DG-1327 Clarification

Reactivity Initiated Accident Guidance

EPRI Fuel Reliability Program, Reg-TAC Chair

January 25, 2017 • White Flint, Rockville MD

Failure Thresholds

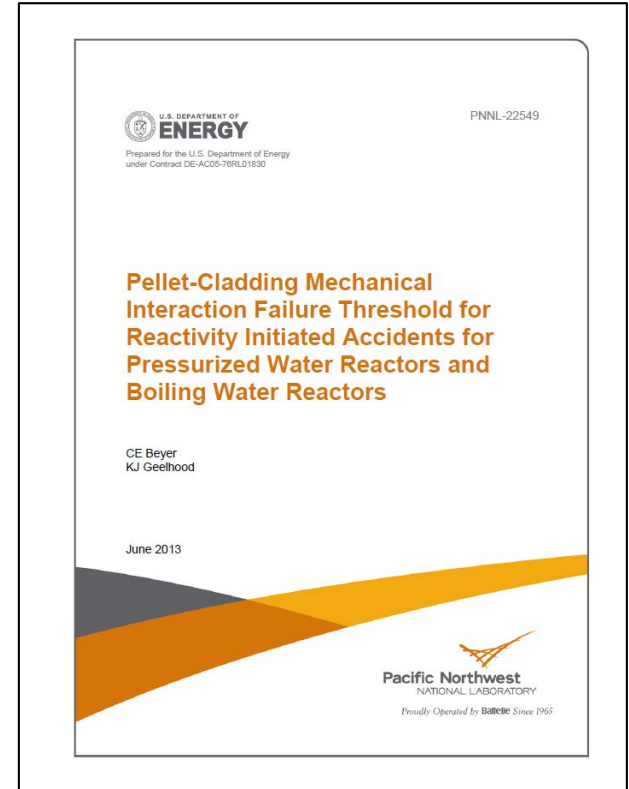
- **Best Estimate?**
 - Yes, in the sense that curve fits are relative to nominal data.
 - No, in the sense that the shape of curve fits displays negative impact in areas without failures
 - **Low Hydrogen region**
 - No, in the sense that correlation coefficients are in some cases substantially less than 1

Release Fractions

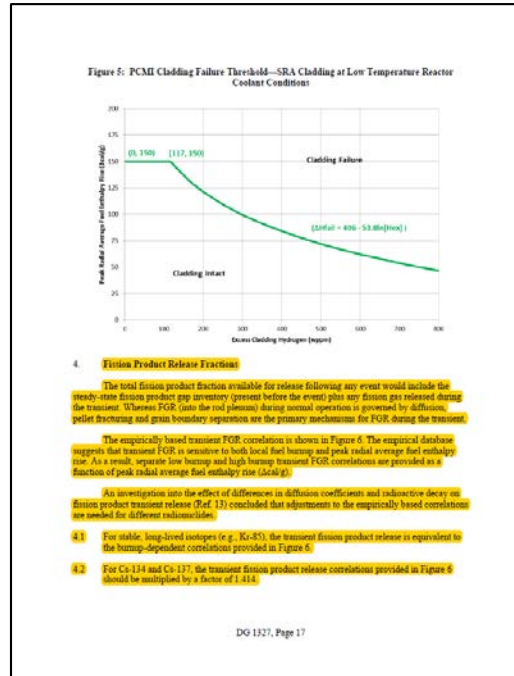
- **Appropriate Location**
 - Keep information in one place; remove from DG-1327
 - Locate to 1.183, 1.195, etc. (sign of a bigger problem)
- **Example: Changing dose method constitutes an AST/TID backfit?**

Release Fractions

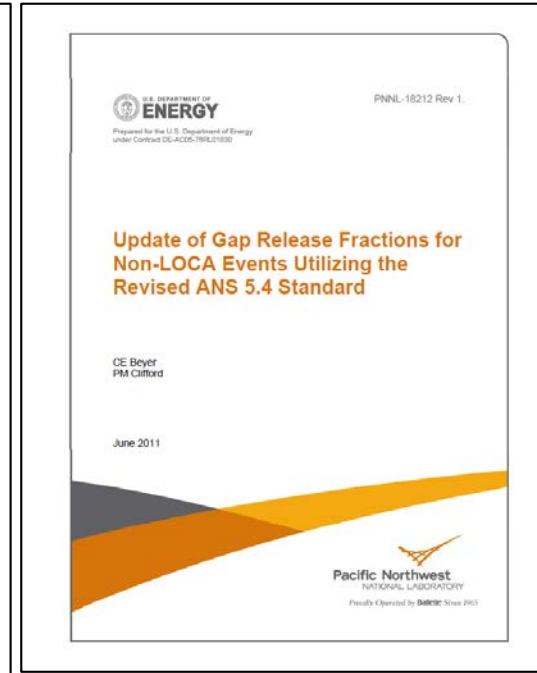
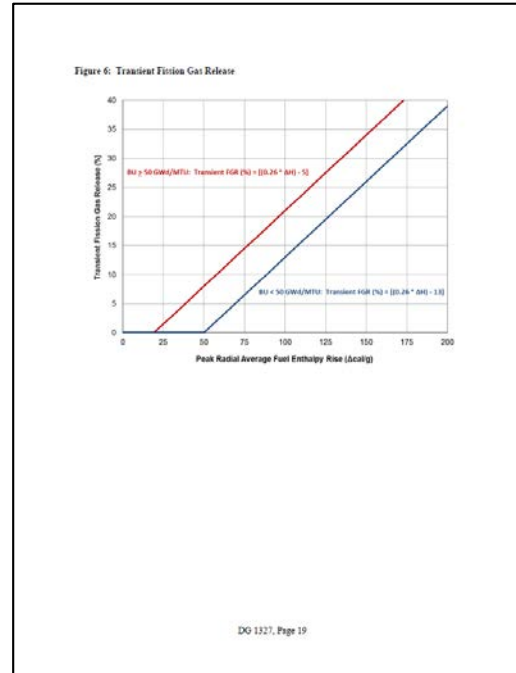
- Transient Fission Gas Release
 - Database doesn't represent low burnup
